2. Forest Acres & Fort Raymond Sub Seward Gateway Properties

KPB file 2025-178R1

**ITEM #2 - PRELIMINARY PLAT
FOREST ACRES SUBDIVISION SEWARD GATEWAY PROPERTIES**

KPB File No.	2025-178R1
Plat Committee Meeting:	May 26, 2026
Applicant / Owner:	<ul style="list-style-type: none"> • City of Seward • Robert W. Williams of Las Vegas, Nevada • Travis E. Maurer of Gig Harbor, Washington
Surveyor:	Stacy Wessel / AK Lands, Land Surveying LLC
General Location:	Seward south of Resurrection River

FOREST ACRES AND FORT RAYMOND SUBDIVISION SEWARD GATEWAY PROPERTIES

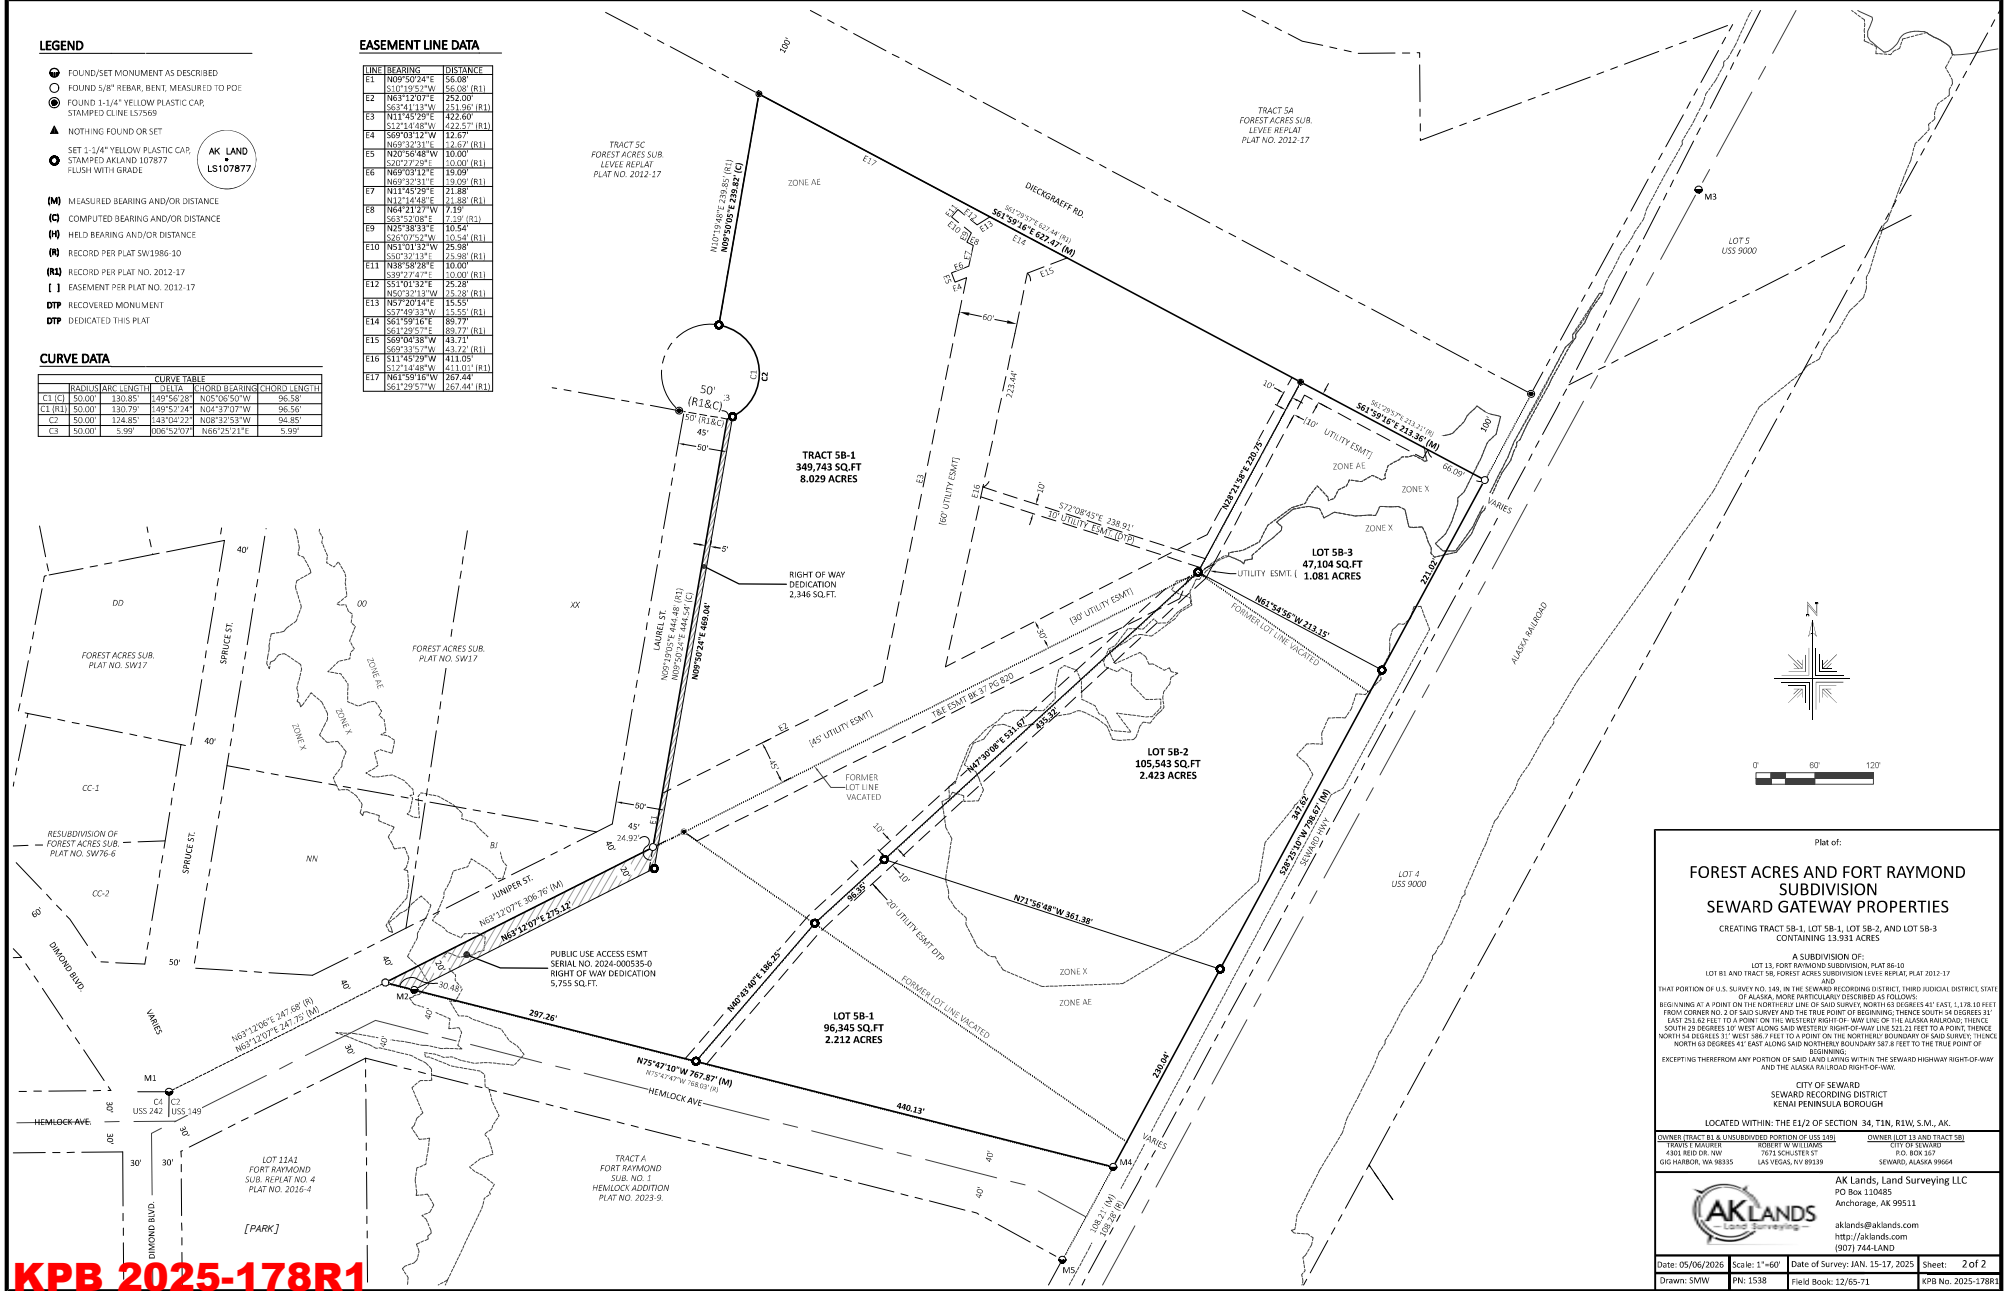
Proposed lots 5B-1, 5B-2, and 5B-3 all front the Seward Highway on the eastern boundary. The SOA DOT&PF has stated that there is to be no direct access to the Seward Highway for any new lots. Proposed Lot 5B-1 will be required to access Hemlock Avenue and proposed Lot 5B-3 will be required to access Dieckgraeff Road. **Staff recommends** a plat note be added to the final plat submittal indicating the restricted access for the proposed lots.

Available data indicates an access point from proposed Lot 5B-3 to the Seward Highway. According to the SOA DOT&PF, any previously issued access permits become invalid once the property undergoes a platting action and must be reissued. This platting action voids the previous permit.

The only legal access for proposed Lot 5B-2 is the Seward Highway. Based on the SOA DOT&PF review, access is denied for the Seward Highway and a re-design of the lot is necessary to provide legal access. **Staff recommends** the applicant comply with DOT&PF's request or provide written confirmation of an agreement indicating access to the Seward Highway, a copy of the written agreement will be acceptable.

Several easements are noted in the plat notes and shown if possible. Staff recommends those shown on the drawing be tied to the plat notes associated to them.

The plat is not indicated a utility easement adjacent to road rights-of-way. The plat is subject to City of Seward Zoning regulations. Unless the City has any set width, **staff recommends** the surveyor confirm with the City of Seward a utility easement and add a note with width or use KPB 20.30.060 as a standard width of 10’.

Modify the date in the Plat Approval to May 26, 2026.
Add measurement to the lots.

Label the new and proposed easements crossing the plat.

Plat of:
FOREST ACRES AND FORT RAYMOND SUBDIVISION SEWARD GADGETY PROPERTIES
 CREATING TRACT SB-1, LOT SB-1, LOT SB-2, AND LOT SB-3 CONTAINING 13.933 ACRES

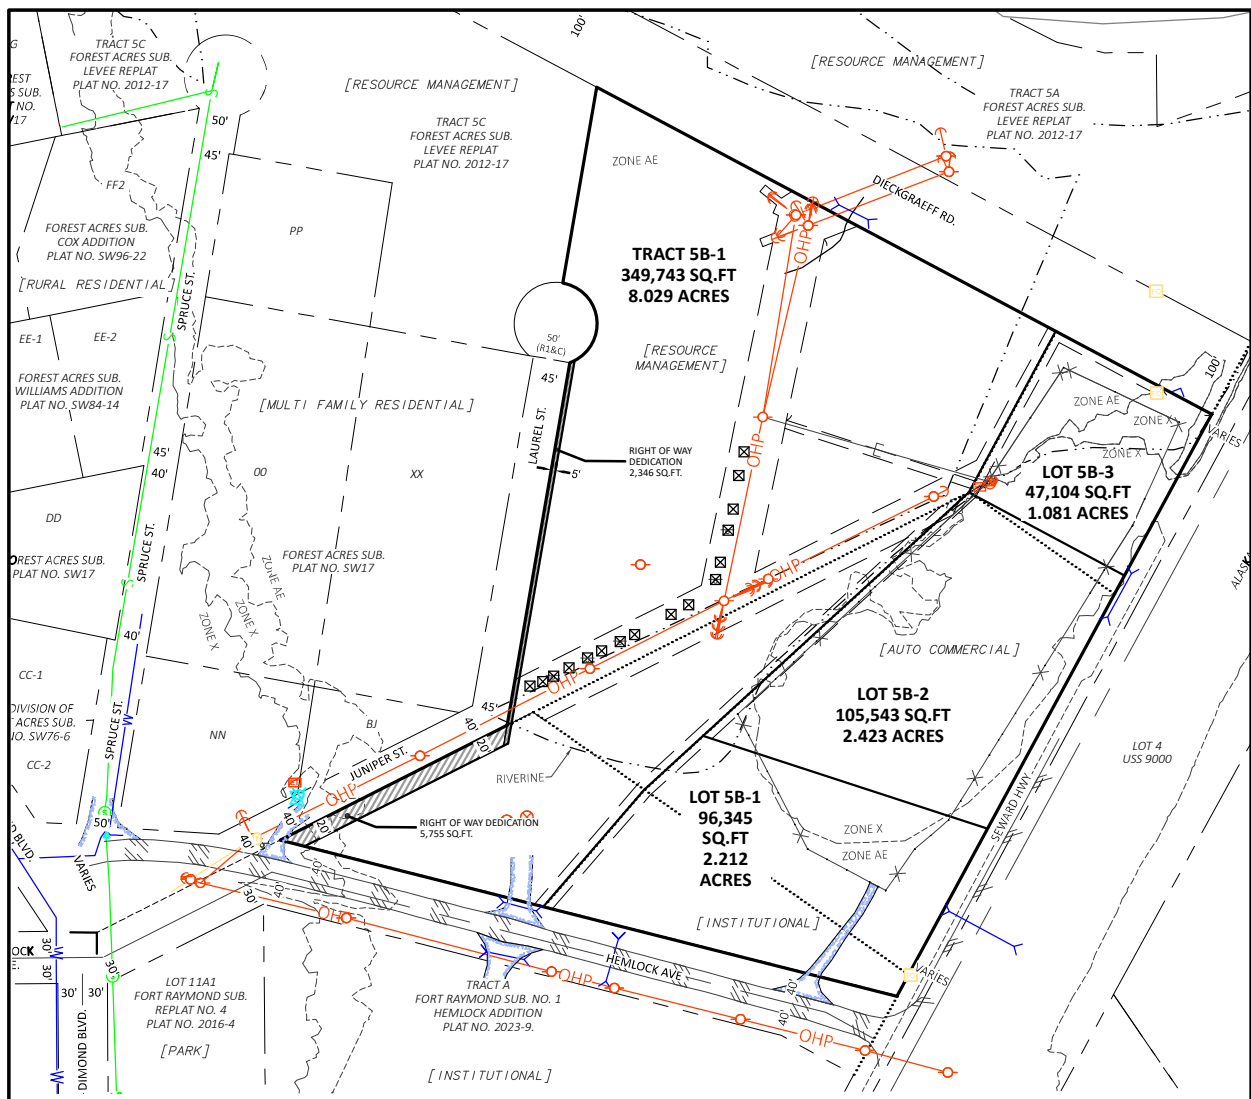
- **Forest Acres and Forth Raymond Subdivision Seward Gateway Properties (KPB 2025-178R1)**
 - No direct access to Seward Highway for all lots.
 - Applicant should reconfigure proposed lots to allow all lots to access through Hemlock Avenue and Dieckgraeff Road, or some other form of internal circulation that excludes direct access to the Seward Highway.

- Access for Lot 5B-2 could be through Laurel St, Juniper St, Hemlock Ave, and Dieckgraeff Road via access easement or flag lot, or similar, depending on applicant's preference.
